SUBJECT: Negative Declaration for Hanapepe Drainage Improvement
Project, TMK: 1-8-08:45, Hanapepe, Kauai, Hawaii

ENVIRONMENTAL ASSESSMENT
FOR THE
HANAPEPE DRAINAGE IMPROVEMENT PROJECT

VIII. COMMENTS AND RESPONSES TO COMMENTS FROM
REVIEW AGENCIES

STATE LAND USE DISTRICTS

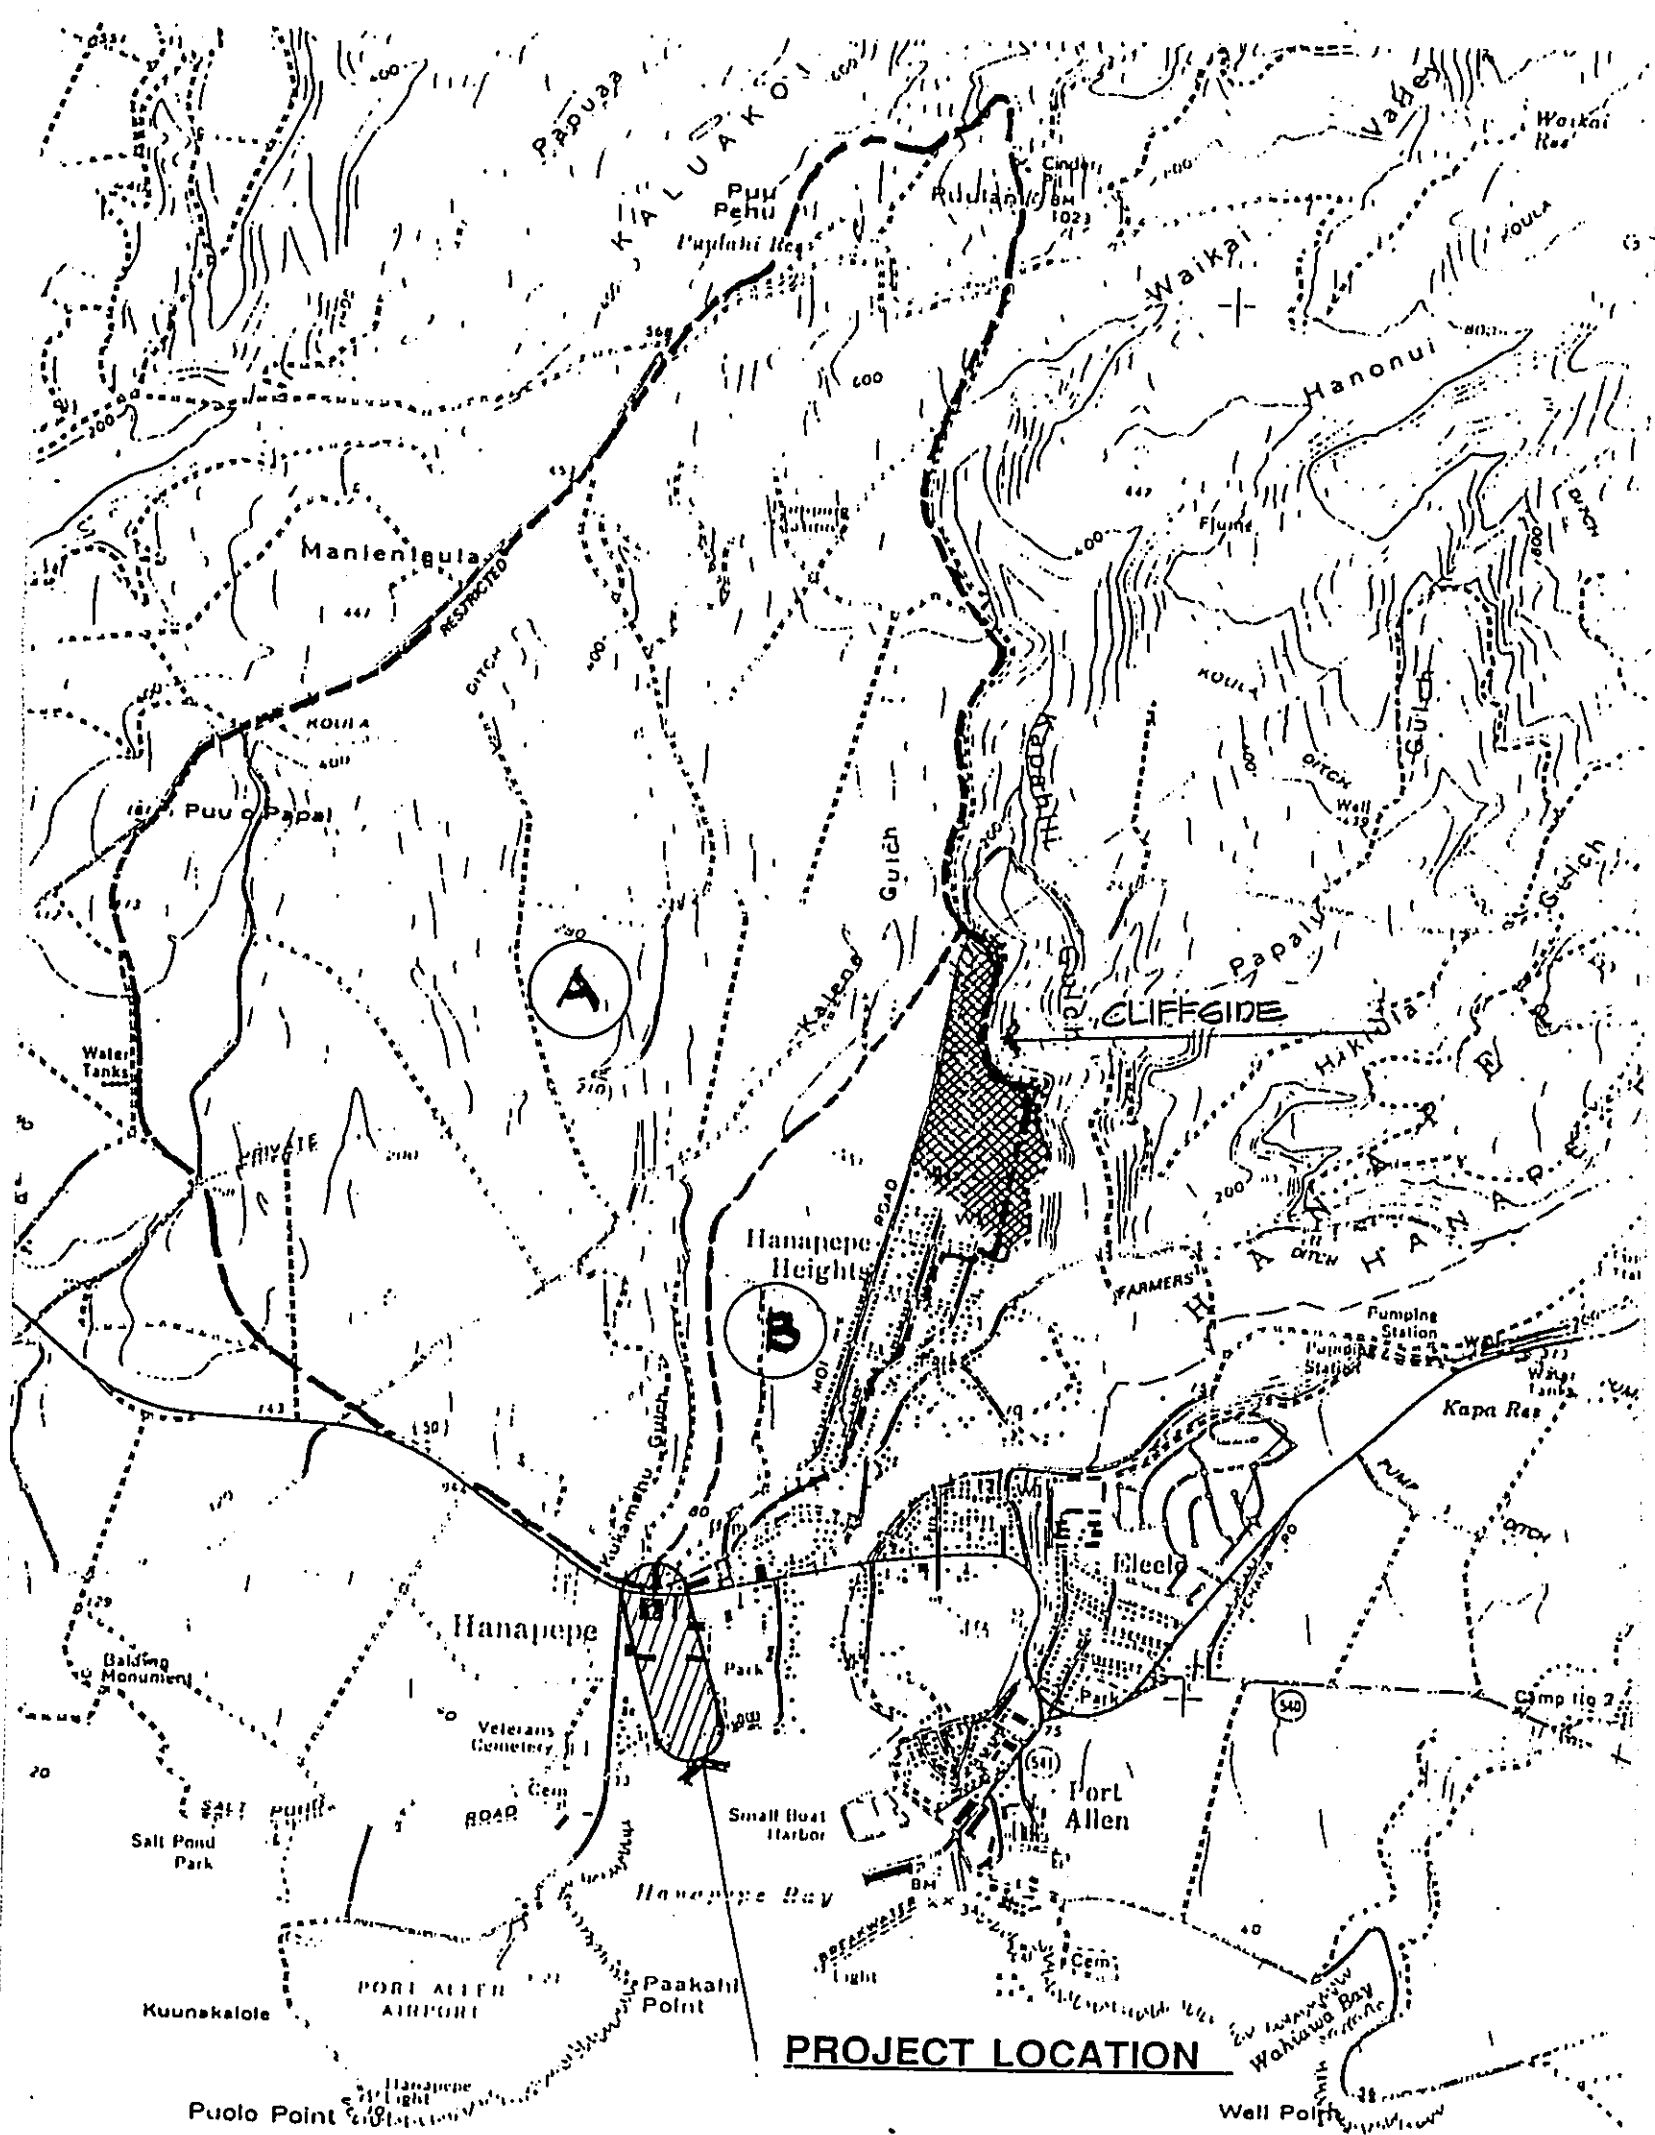
The Office of Conservation and Environmental Affairs (OCEA) comments that Final EA should provide tax map key (TMK) and State Land Use District information for the project area. The Final EA should also include maps illustrating both the TMK and Land Use Districts boundaries in relation to the project area.

Office of Conservation and Environmental Affairs: All projects will occur within the Urban District except for the first item, the provision of box culverts under Hanapepe Road, of which the majority of the work will take place in the Agriculture District. No work will be performed on the bed or banks of existing streams. Work Item 3 is the widening of an existing drainage channel, not stream, and therefore a Stream Channel Alteration Permit is not required.
